Comparison of power budget methodology

Dudek_01_0910

September 21 2010

Budget methodology comparison with Clause 38 alternate version (backup)

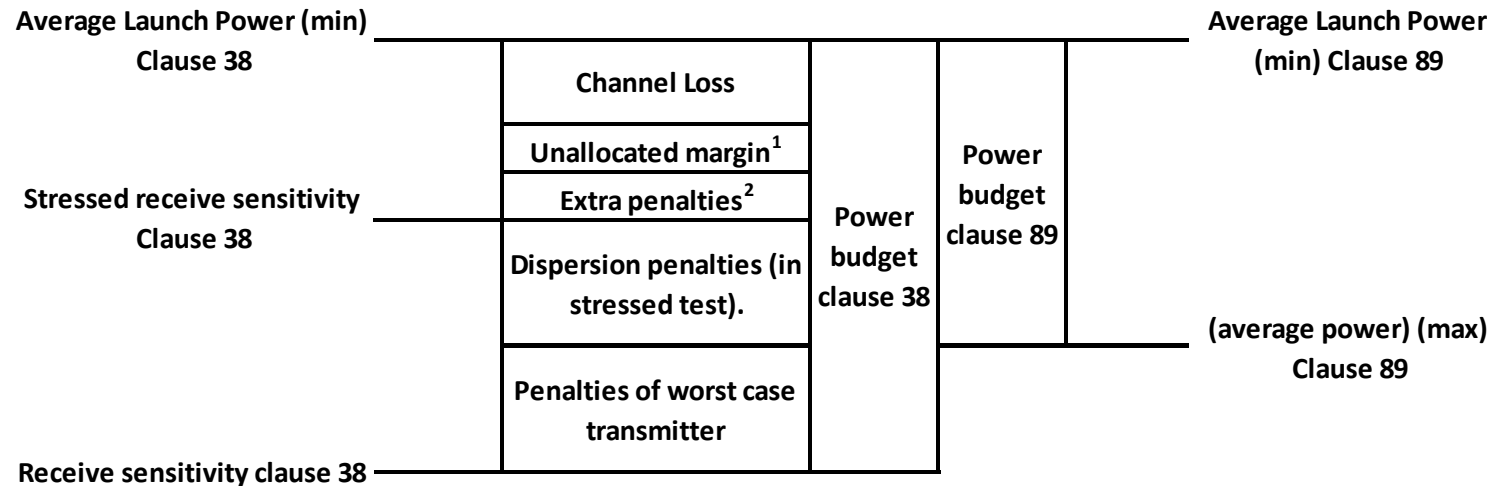
This clause uses the budgeting methodology that is used for application VSR2000-3R2 in ITU-T G.693 [Bx1] which is different from the methodology used in other clauses of this standard. Figure new (same as slide 6) shows the key difference and the terminology used in this clause compared to clause 38. The most important difference is that receiver sensitivity in this clause is specified with a worst-case transmitter input whereas in other clauses it is specified with a perfect signal without penalties.

1. The Unallocated margin is zero in clause 89.
2. Extra penalties are any penalties that are not included in the stressed test.

89.6.4 Comparison of power budget methodology
